CHALLENGER OF RECORD & DEFENDER AMERICA'S CUP 36

Interpretation 045 of AC75 Class Rule Version 1.9 issued 20th March 2020

Figure 1

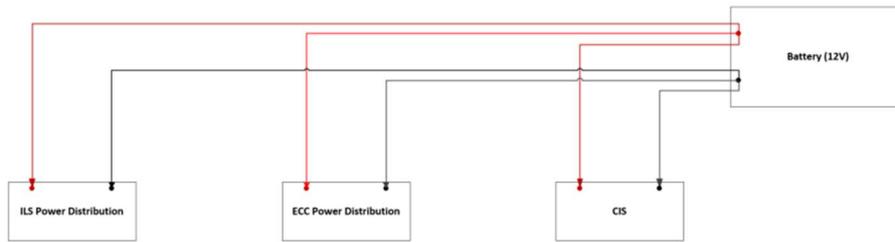
- I. Figure I shows a simple power distribution circuit. The lines shown are independent wires that feed power from the battery to these systems for use as otherwise allowed by the **AC75 Class Rule**. The only contact between these wires happens at the terminals of the battery. Elsewhere these wires are electrically insulated and physically separated. The **ECC** power distribution supplies power to **electric actuators** that do work on a **control surface**.

- a. Is the battery part of the **CIS**, **ILS** or **ECC**? If so, which one?
 - b. Does this circuit comply with the **AC75 Class Rule**? If not, which rules are infringed by the arrangement, and how are those rules infringed?
2. Figure 2 shows a modification to Figure 1, whereby the **ECC** and **ILS** circuits are electrically grounded to the structure of the boat, in addition to being connected to the negative terminal of the power source.

1.
 - a. Yes. The battery is shared by the **CIS**, **ILS**, and **ECC**.
 - b. Yes.
2. No. If, as in figure 2 of the request for interpretation, the **ECC** and **ILS** have conductors to ground as a part of their wiring, then the **ECC** and **ILS** wiring are not isolated. Case grounded hardware such as motors and screens that are part of an **ECC** or **ILS** are not required to be isolated from the hull, but their wiring is.

Figure 2

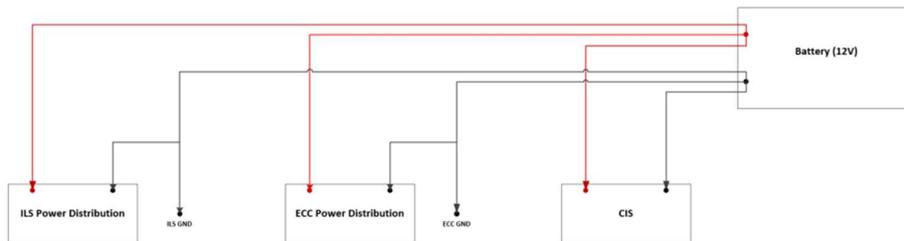
Does this circuit comply with the **AC75 Class Rule**? If not, which rules are infringed by the arrangement, and how are those rules infringed?

Figure 3

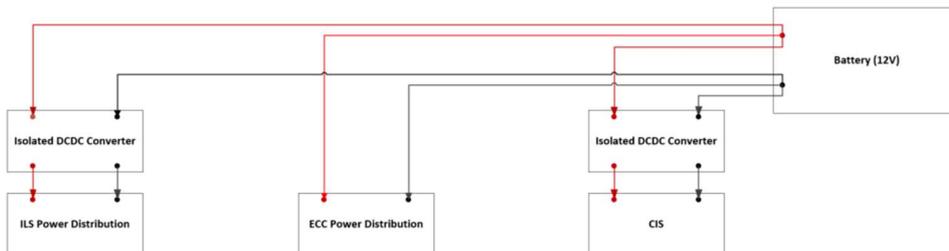
3. In figure 3, the separate circuits are additionally isolated from one another by the installation of isolated DC-DC converters, with the grounding points removed.

Does this circuit comply with the **AC75 Class Rule**? If not, which rules are infringed by the arrangement, and how are those rules infringed?

3. Yes.
4.
 - a. Yes.
 - b. The buffer battery shown in figure 4 may be selected by the **competitor** to suit the application.
 - c. Yes.
 - d. Yes.
 - e. If the DC-DC converter allows any current to flow from the buffer battery to the **FCS** battery, the buffer battery “expands” the **FCS** battery and therefore is subject to Rule 27.7 and therefore the **FCS** specification.

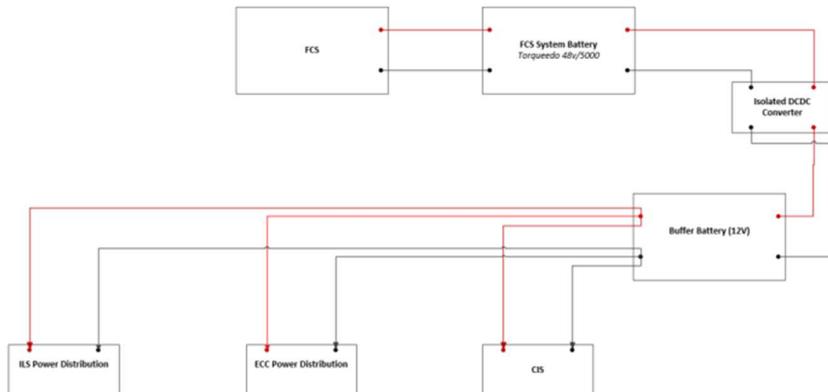
4. Figure 4 shows an alternative system. Power is taken from the **FCS** battery (as allowed by rule 27.8a) to power other systems, via a buffer battery. The specification of the isolated DC-DC converter is such that power can only flow from the **FCS** battery into the buffer battery.

- Is the buffer battery considered a “battery or regulated power supply” as per rule 23.6?
 - If so, must this battery be a “specified battery model” per rule 27.7, or may it be selected by the **competitor** to suit the application?

- Does this circuit comply with the **AC75 Class Rule**? If not, which rules are infringed by the arrangement, and how are those rules infringed?
 - Do the answers to question (c) change if the DC-DC converter allowed power to flow in both directions, rather than solely from the **FCS** battery to the buffer battery?

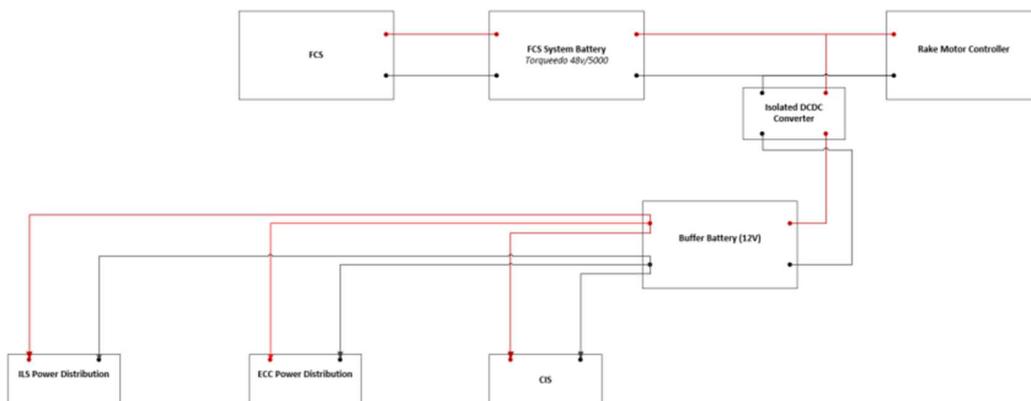
- If the answer to question d above is “yes”, how and why do those answers change?
5. Figure 5 shows an additional arrangement fundamentally identical to that described in question 4, except that a component of the **ECC** (containing only **electric actuators** as permitted by rule 24.2) takes power directly from the 48V system. The specification of the isolated DC-DC converter is such that power can only flow from the **FCS** battery into the buffer battery.

- Does this circuit comply with the **AC75 Class Rule**? If not, which rules are infringed by the arrangement, and how are those rules infringed?
- Do the answers to question (a) change if the DC-DC converter allowed power to flow in both directions?
- If the answer to question b above is “yes”, how and why do those answers change?

The text in question 5 and figure 5 are inconsistent. The text describes the component of the **ECC** as “containing only electric actuators [...]”. The figure has the box labelled “Rake Motor Controller”, which includes control electronics. The answers below treat both as components of an **ECC**.

5.
 - a. No. Rule 23.6 requires that **ECC** wiring be isolated. In figure 5, a component of the **ECC** has wiring that is not isolated. With the general arrangement shown, if the **ECC** component and the isolated DC-DC converter are each connected directly and independently to terminals on the **FCS** battery, rather than being interconnected as drawn, the circuit would comply.

- b. No, because the wiring requirements laid out in answer 5.a. are not met. See also answer 4.e, above for additional constraints on this arrangement even if the wiring is modified as specified in answer 5.a.

- c. Not applicable.
